Re: [2023065] – OPUS Transport Apartments – Flightway Ave. at University Blvd. in Albuquerque, NM.

The purpose of this letter is to provide the responses and clarification to comments and questions from the City of Albuquerque pertaining to the draft Traffic Impact Study associated with the subject project, OPUS Transport Apartments located at Flightway Ave. at University Blvd. in Albuquerque, NM.

**Figure 3B-23. Examples of Parking Space Markings**

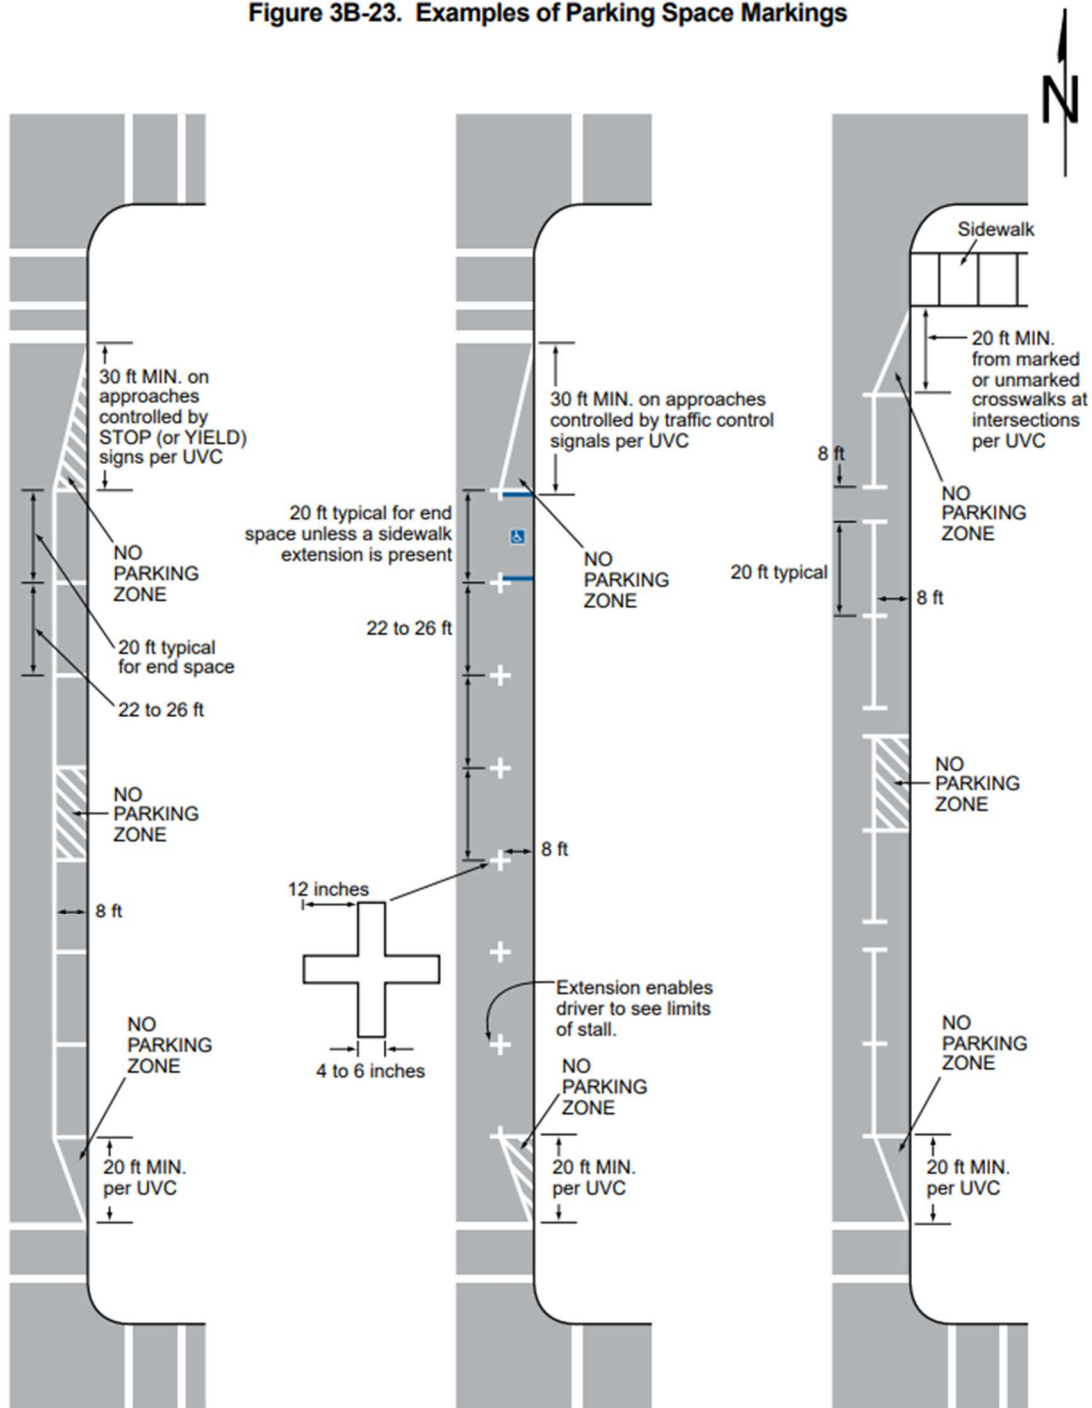
- c) Please extrapolate/provide details on the recommendation “Striping is recommended along the entire roadway to delineate lanes...”.

*The recommendation is to continue on-street parking along Transport St. on the east and west sides, as well as recommended improvements to the existing on-street pavement marking. Improvements include the striping of the parking space to meet MUTCD Section 3B.27 Parking Space Markings standard applies the following:*

*On-street parking space markings shall be white.*
